## Access Compliance Report Public Rights-of-Way (Curb Ramps)

Intersection ID: N/AMain Street: E\_4TH\_STCross Street: N/ALocation:SADA ID: 8B155904E36ERamp Type: PerpInitial Pass/Fail: FailOverall Compliance: NoSeverity Score: 13.75

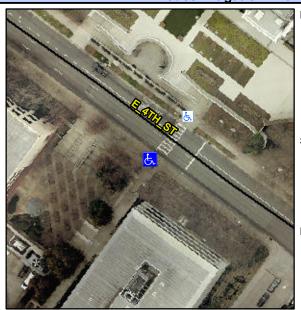
Field Measurements/Component Compliance						
Comp	liance Description	Data	Comp	liance	Description	Data
N/A	Ramp Length (in)	76.0	No	Ram	Slope (%)	8.9
Yes	Ramp Width (in)	53.0	Yes	Ram	XSlope (%)	2.4
N/A	Flare Type LT	N/A	N/A	Flare	Type RT	N/A
N/A	Flare Slope LT (%)	N/A	N/A	Flare	Slope RT (%)	N/A
N/A	Flare Traversable LT?	No	N/A	Flare	Traversable RT?	No
N/A	Landing Length (in)	N/A	N/A	DWS	Provided?	N/A
N/A	Landing Width (in)	N/A	N/A	DWS	Contrast?	N/A
N/A	Landing Slope (%)	N/A	N/A	DWS	Length (in)	N/A
N/A	Landing X Slope (%)	N/A	N/A	DWS	Full Width?	N/A
N/A	Landing Curb? (Y/N)	N/A	N/A	DWS	Offset (in)	N/A
N/A	Shared Landing?	N/A				
N/A	Gutter Ponding?	N/A	N/A	Gutte	er Slope (%)	N/A
N/A	Gutter Lip Ht (in)	N/A	N/A	Gutte	er X Slope (%)	N/A
N/A	Painted X Walk1?	Yes	N/A	Paint	ed X Walk2?	N/A
	X Walk 1 Direction	To NE		X Wa	lk 2 Direction	N/A
N/A	X Walk 1 Width (in)	32.0	N/A	X Wa	lk 2 Width (in)	N/A
	X Walk 1 Slope (%)	6.5		X Wa	lk 2 Slope (%)	N/A

X Walk 1 X Slope (%)	4.4		X Wa	lk 2 X Slope (%)	N/A
N/A	Ramp inside XWalk1?	Yes	N/A	Ram	o inside XWalk2?	N/A
	Road Slope (%)	N/A	N/A	Clear	Space?	N/A
	Road X Slope (%)	N/A	N/A	Clear	Space to XWalk (in)	N/A
N/A	Any Obstructions?	N/A	N/A	Storn	n Grate/Utility Hazard?	N/A
	Obstruction Type			Storn	n Grate/Utility Type	
		N/A				N/A
			Yes	Surfa	ce Condition? (G/P)	Good

Codes/Mitigation Info/Possible Solution

Total Cost: \$ 1850.00
